Vehicles affected: P15R: Senna GTR

Concern: Air jacks leaking

Measure

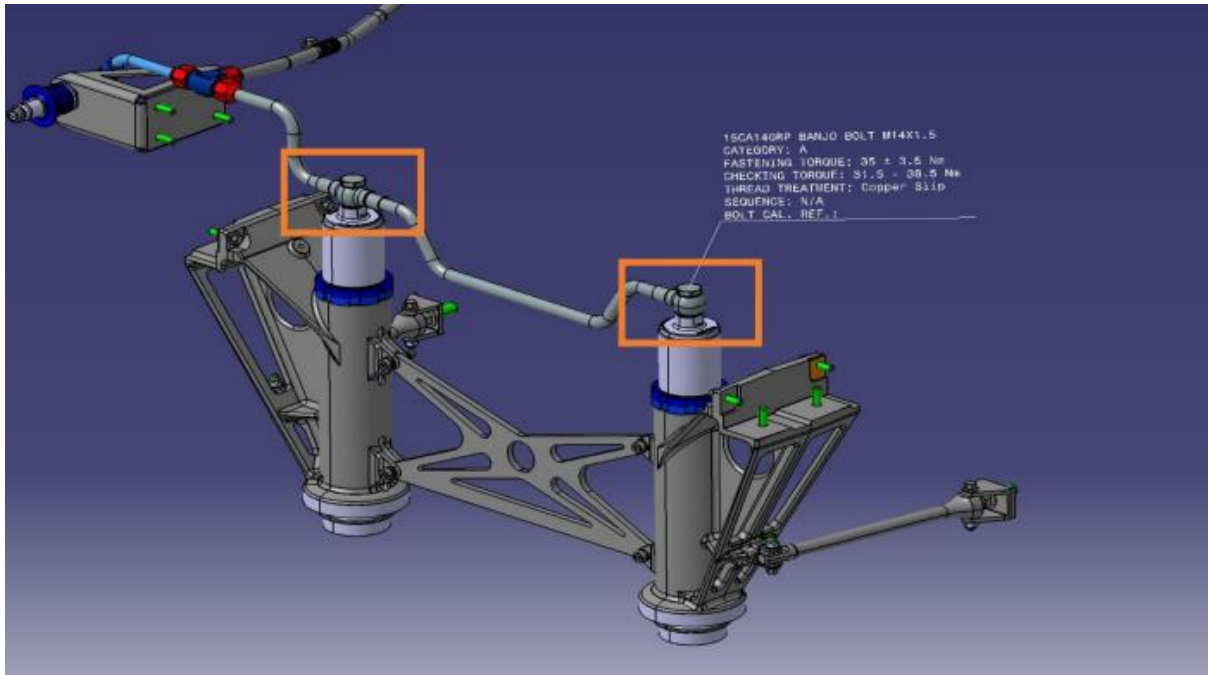
McLaren have identified a potential fault with the McLaren Senna GTR air jack system. As the car is raised on the jacks, the car slowly sinks at the front, rear, individual corners or at all points depending on the component assembly. We therefore request that at the next service booking or track event, all banjo bolts need to be checked for the correct application of copper grease and correct tightening torque.

Correct torque setting:

Banjo bolt: 15CA140RP M14x1.5 @ 35NM

Correct copper grease application:

Only apply copper grease on the thread of the bolt
